DRAFT - WESTLEIGH PARK MOUNTAIN BIKE TRAILS ASSESSMENT 2018

Hornsby Shire Council

Report: December 2018 Report version: FINAL DRAFT V3

PROPOSAL 3

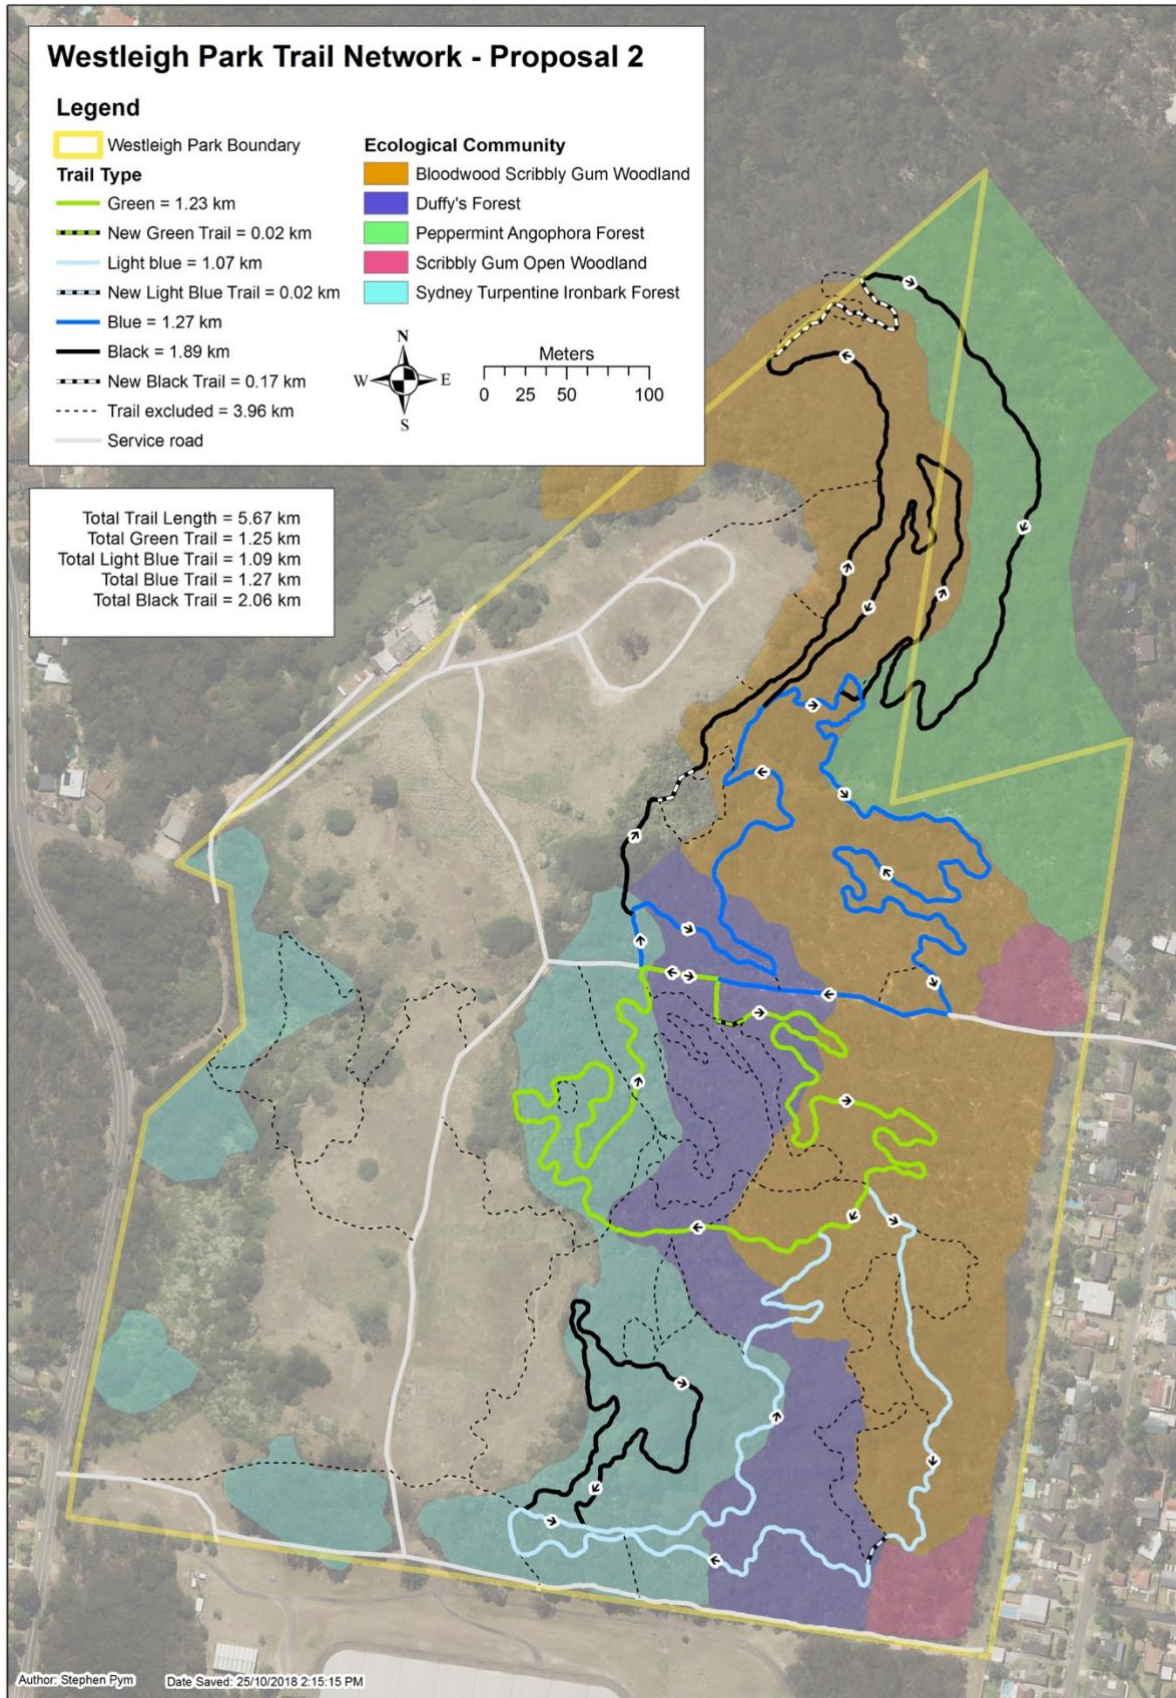
| Proposal | Trail lengths | Summary of proposal | Original score | Revised score | Total Cost estimate GST inc |
|----------|--------------------------------------|---|----------------|---------------|-----------------------------|
| 3 | Provides 3.93km Closes 5.67km | <ul style="list-style-type: none"> Closes more sections of trail in STIF, Duffys Forest and Blackwood Scribbly Gum Woodland than proposals 1, 1B and 5. <u>Does not provide the minimum amount and diversity of trail for a successful 'community' trail network.</u> Removes an entire section of popular advanced trail in the north. | 210 | 190 | \$262 792 |

| Proposal 3 – 3.93 km of trails | | |
|---------------------------------------|--|--|
| Proposal summary | <ul style="list-style-type: none"> • Closes more sections of trail in STIF, Duffys Forest and Blackwood Scribbly Gum Woodland than proposals 1, 1B and 5. • <u>Does not provide the minimum amount and diversity of trail for a successful 'community' trail network.</u> • Removes an entire section of popular advanced trail in the north. | |

| Proposal 3 – 3.93 km of trails | | |
|---------------------------------------|--|--|
| Quantitative score | Original HSC Score - 210 | Revised Score - 190 |

PROPOSAL 5

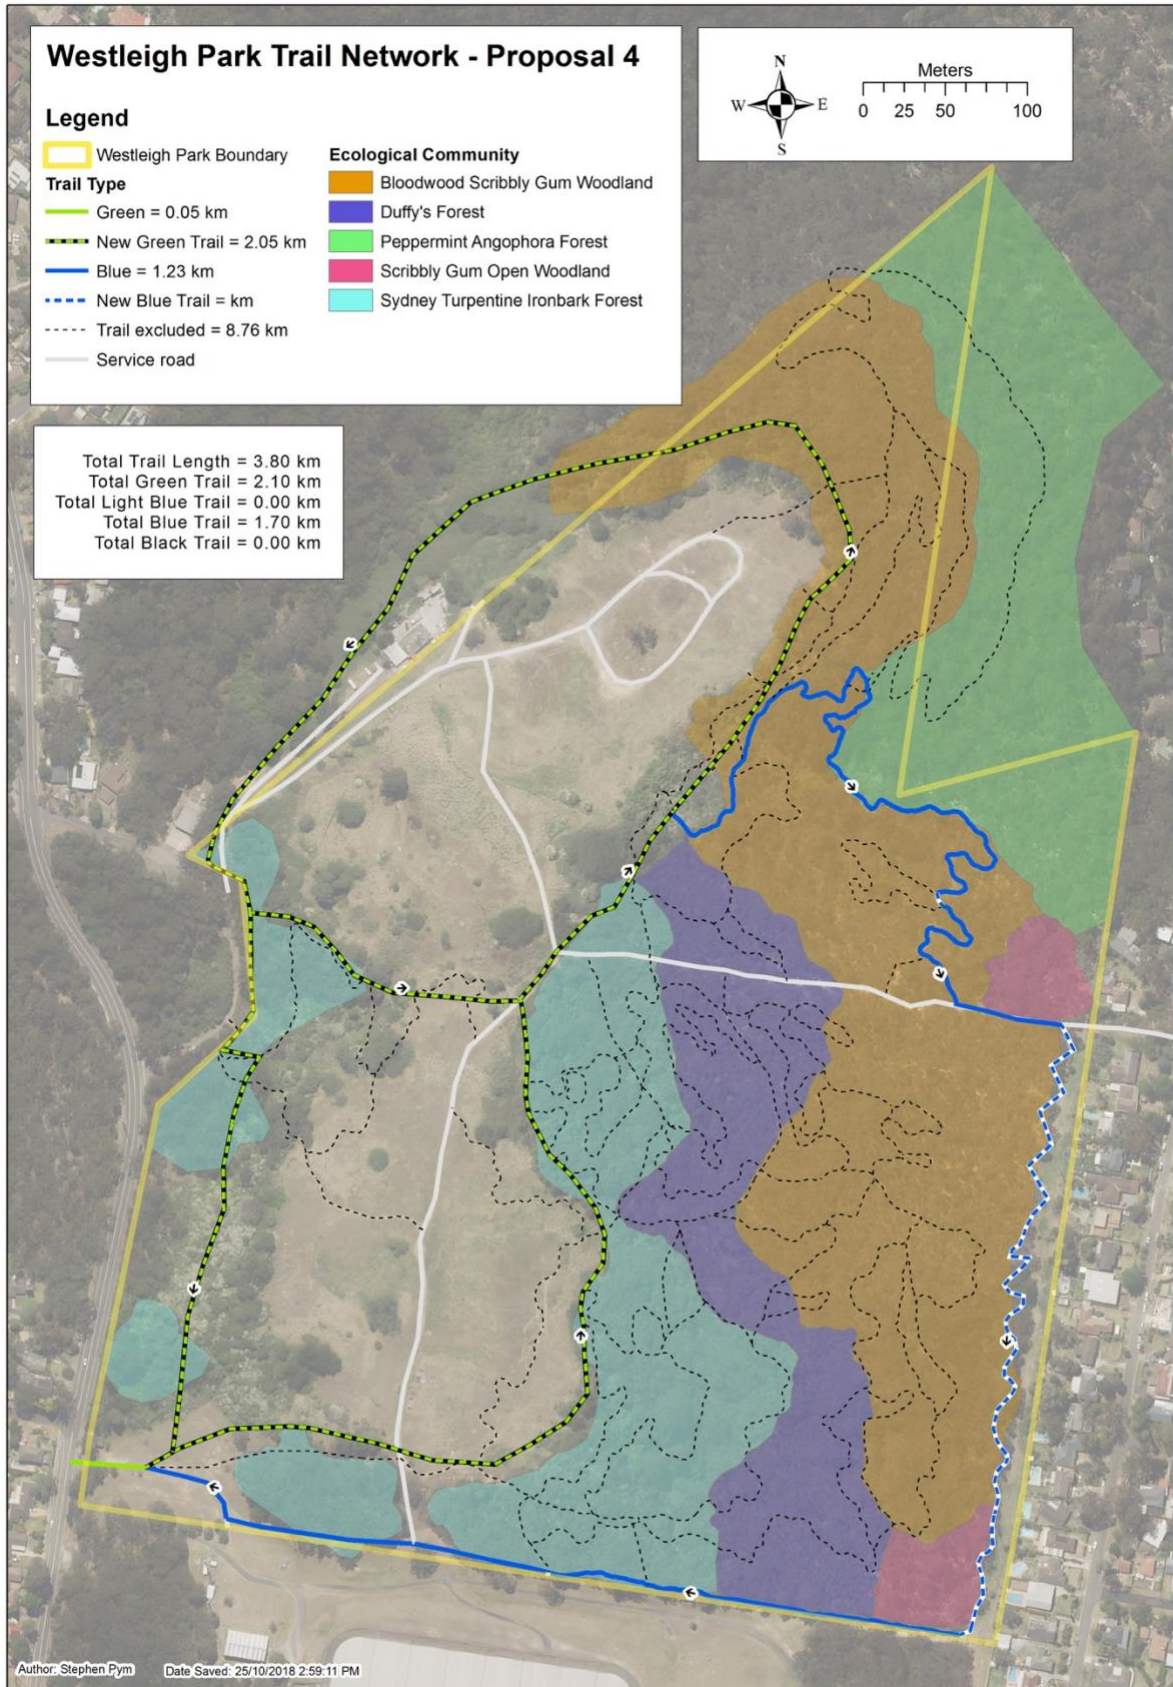
| Proposal | Trail lengths | Summary of proposal | Original score | Revised score | Total Cost estimate GST inc |
|----------|-------------------------------------|---|----------------|---------------|-----------------------------|
| 5 | Provides 9.36km Closes nil | <ul style="list-style-type: none"> This is the entire current network as it exists. Retains all sections of trail in STIF, Duffys Forest and Blackwood Scribbly Gum Woodland than all proposals. Fails to rationalise trails that do not contribute to sound trail network planning. <u>It conflicts with the proposed playing field developments.</u> | 230 | 205 | \$420 800 |

| Proposal 5 – 9.36 km of trails | | |
|---------------------------------------|---|---|
| Proposal summary | <ul style="list-style-type: none"> • This is the entire current network as it exists. • Retains more sections of trail in STIF, Duffys Forest and Blackwood Scribbly Gum Woodland than all proposals. • Fails to rationalise trails that do not contribute to sound trail network planning. • <u>It conflicts with the proposed playing field developments.</u> | |

| Proposal 5 – 9.36 km of trails | | |
|---------------------------------------|---|---|
| Quantitative score | Original HSC Score - 230 | Revised Score - 205 |
